Architect's Supplemental Instructions

PROJECT: *(name and address)*
17-13 OSU College of Med. at Hastings
Tahlequah, OK

ASI INFORMATION:
ASI Number: Bid Package 03 - ASI 02
Date: 05-24-2019

Bid Package 03- ASI 02 – OSU College of Osteopathic Medicine At The Cherokee Nation

SHEET NUMBER: S4.01

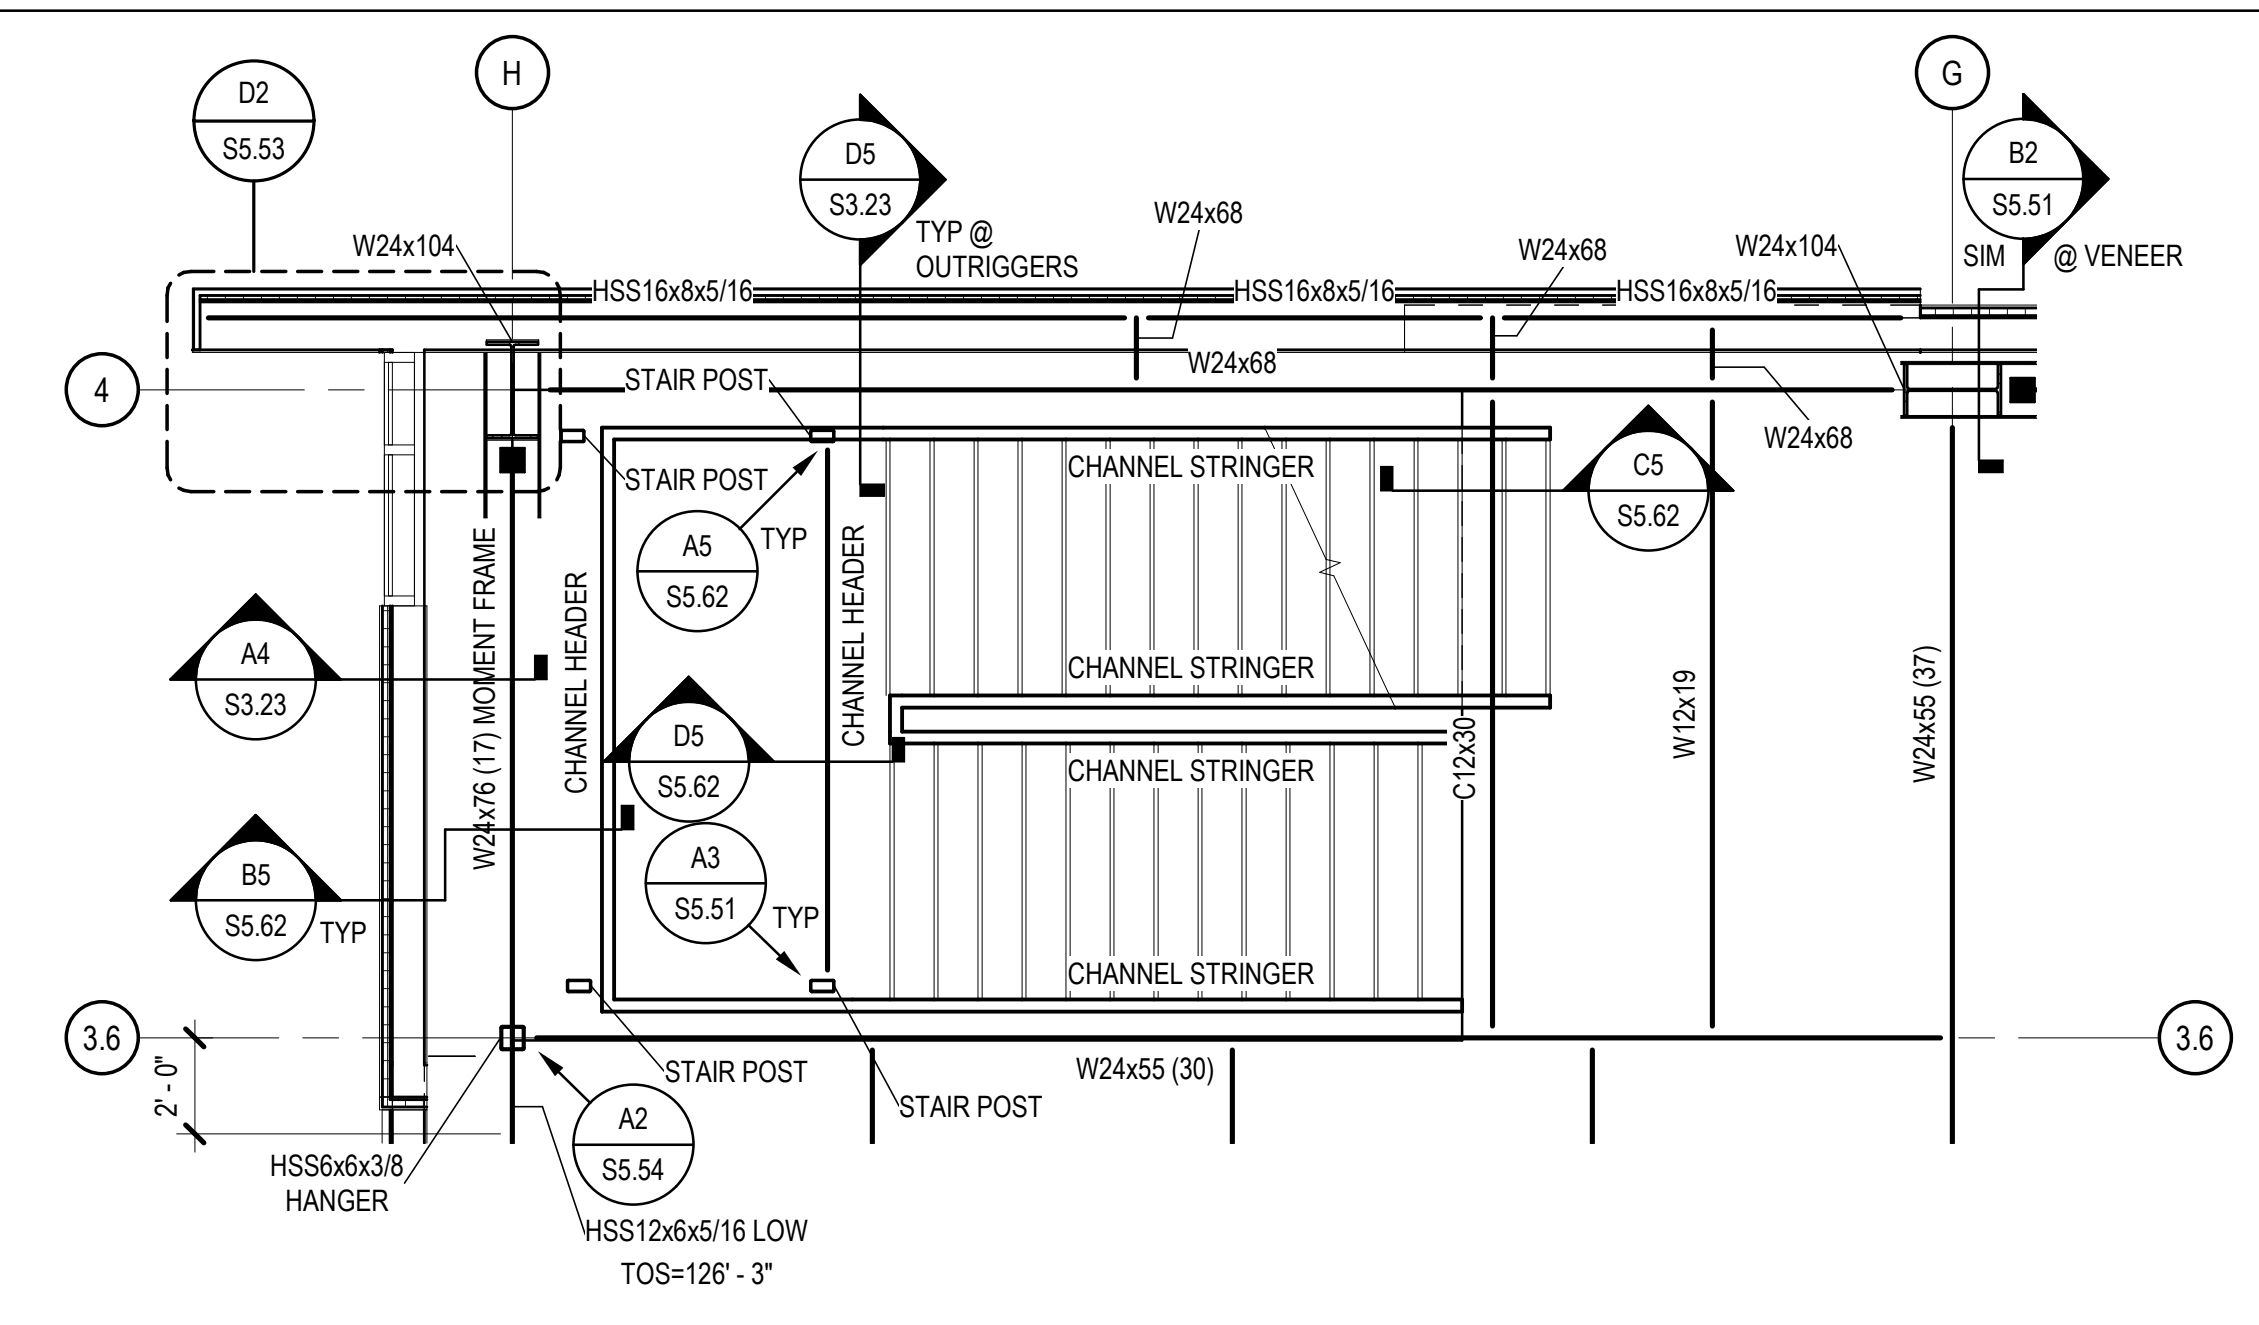
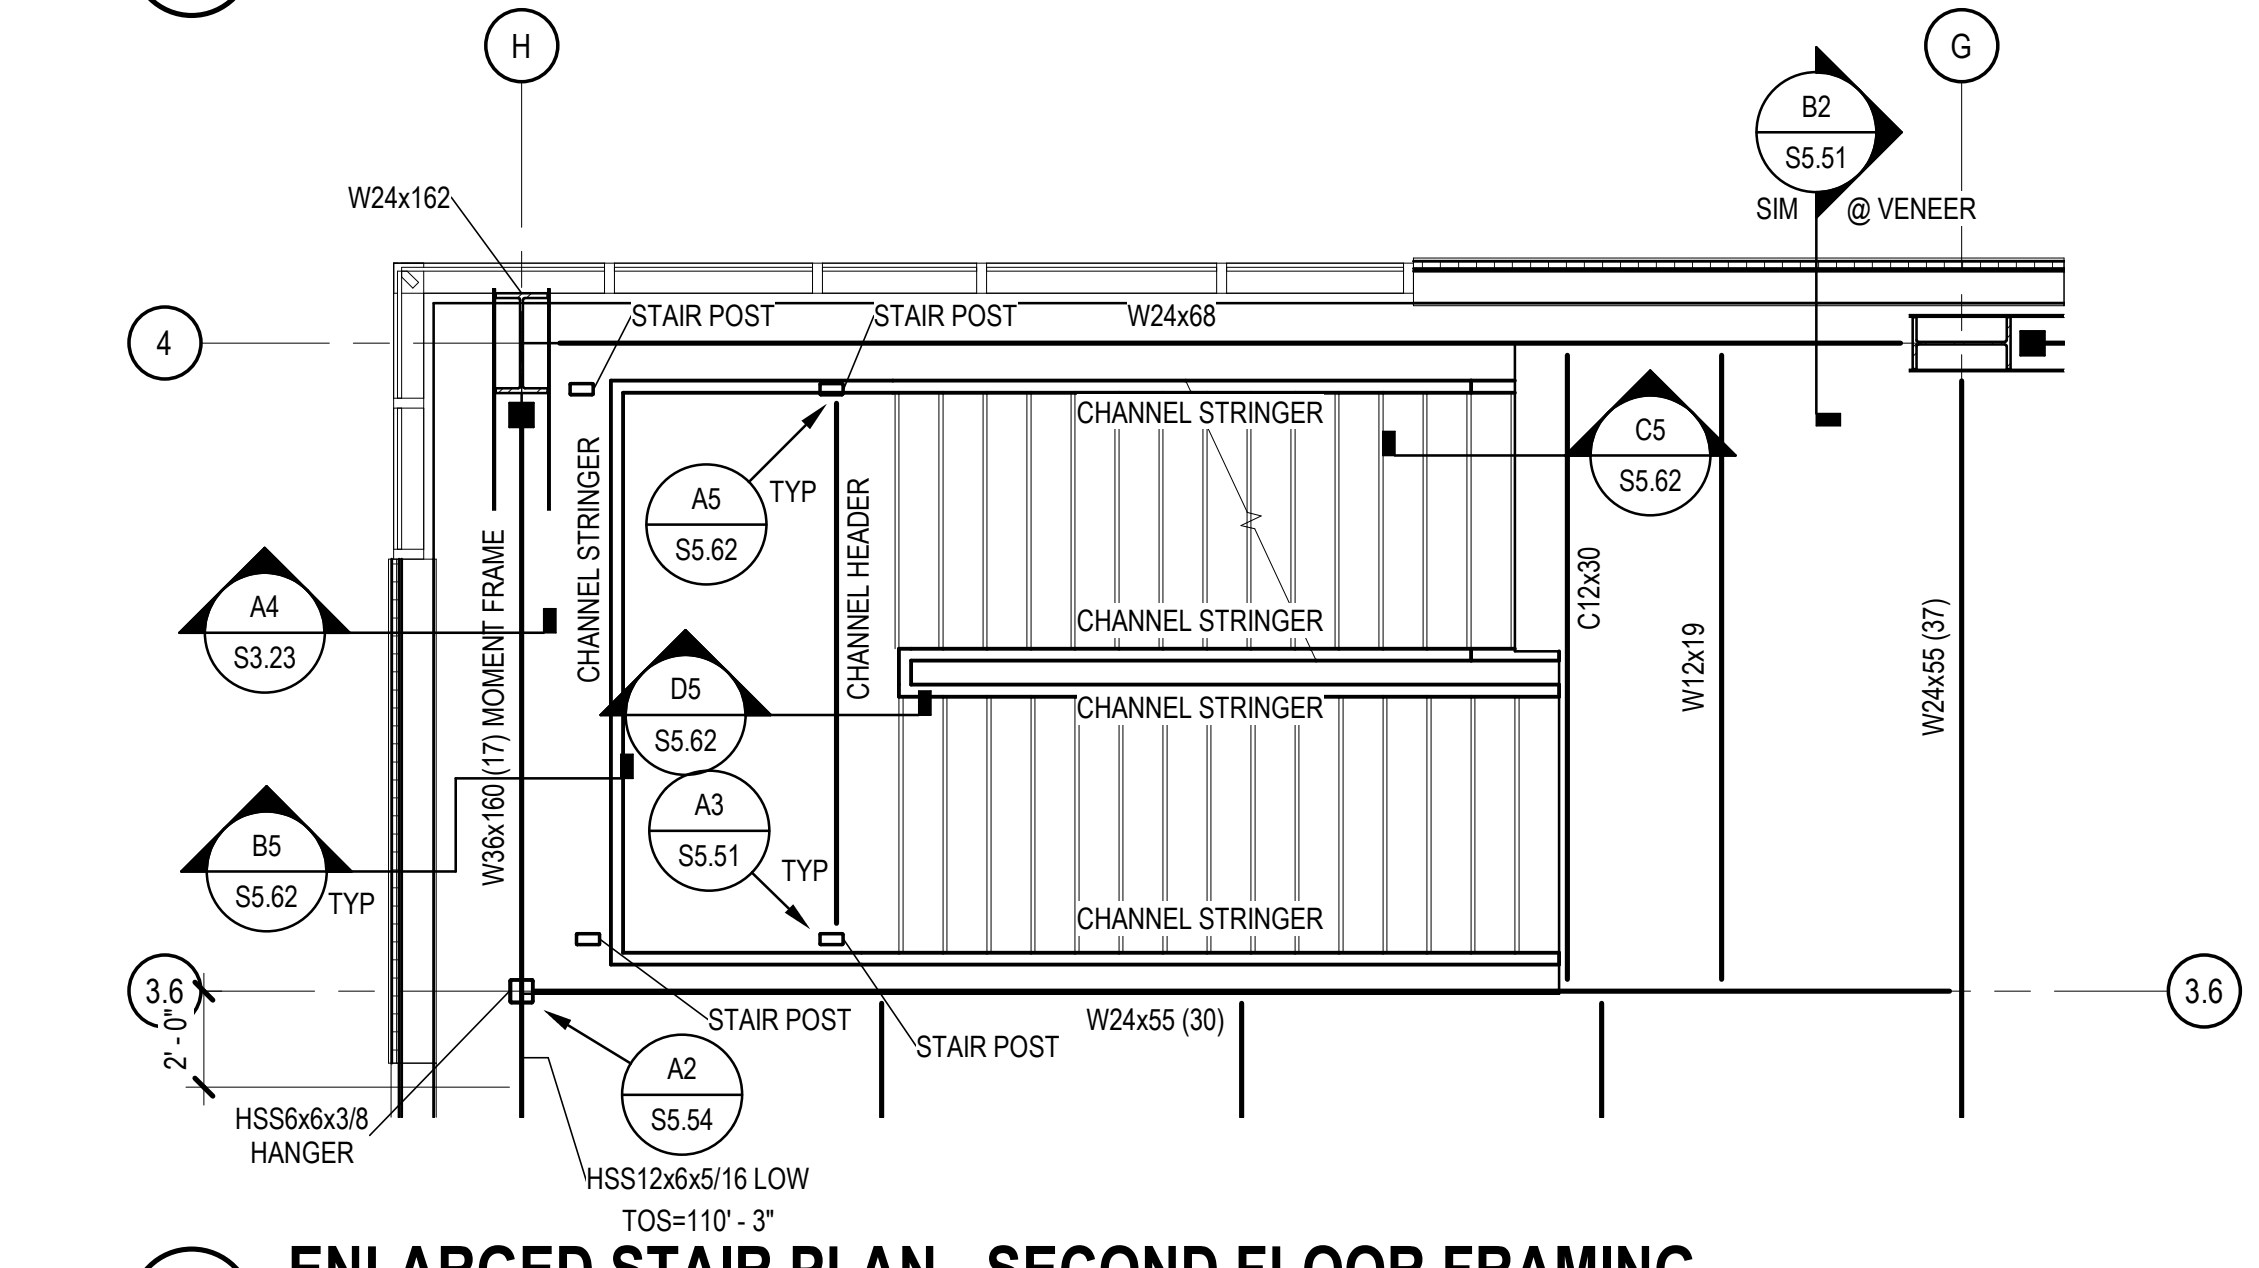
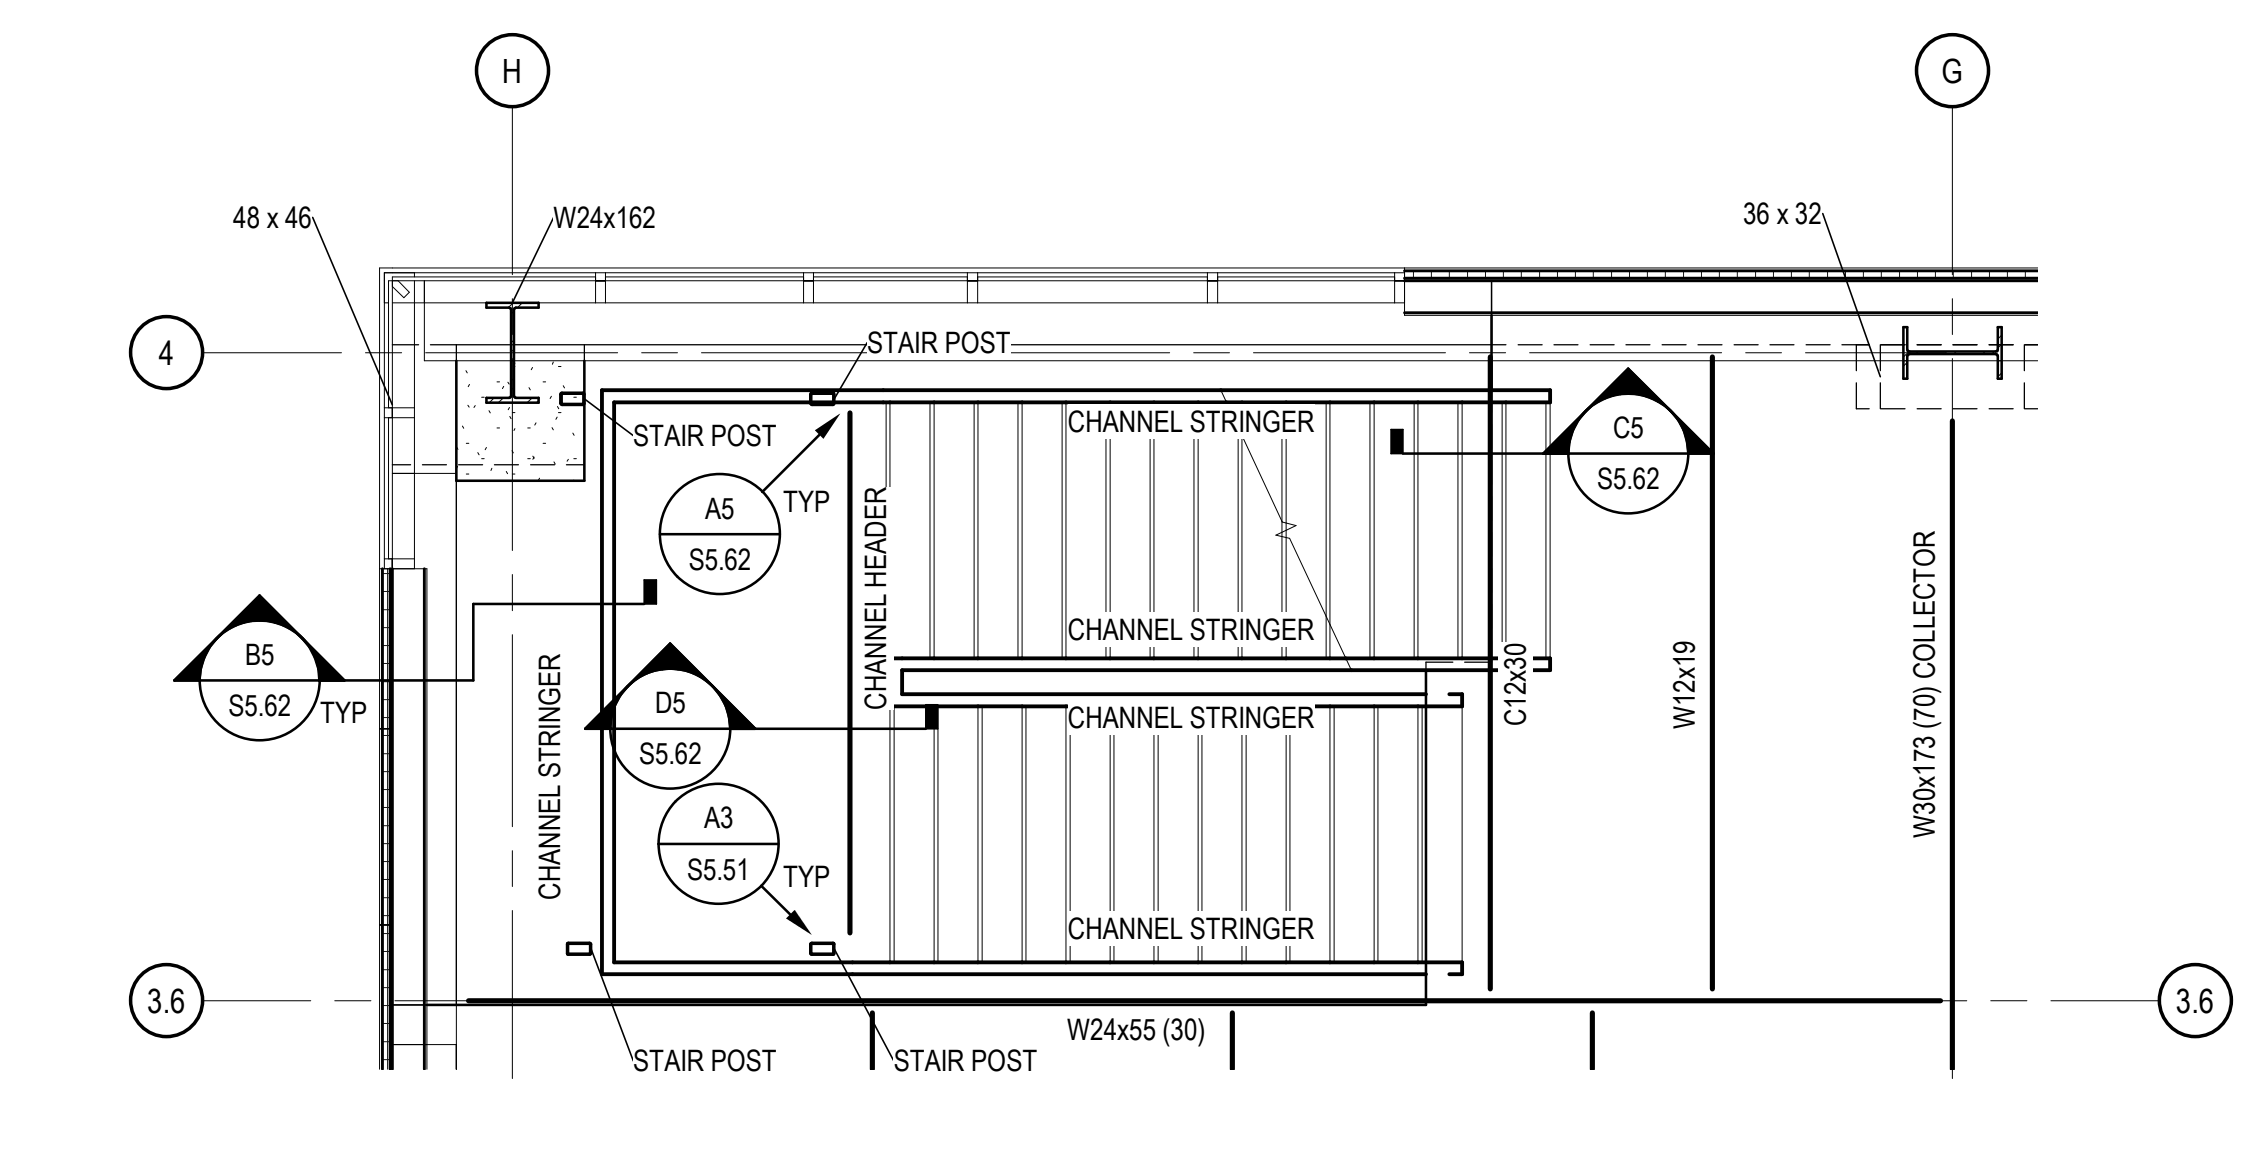
S3.11	Clarifying 'SIM' note added to section D3.
S3.11	Section B5 modified to accommodate raised glazing system.
S3.12	Section B2 added to accommodate raised glazing system.
S3.12	Section B3 modified to include additional beam sizes.
S3.12	Section A1 added to accommodate column furr outs.
S4.01	Entire sheet revised.
S4.02	Entire sheet revised.
S5.11	Clarifying 'SIM' note added to detail C1.
S6.01	Slab-on-grade schedule revised.
S6.01	Additional wall height added to schedule A1.

ENTIRE SHEET REVISED
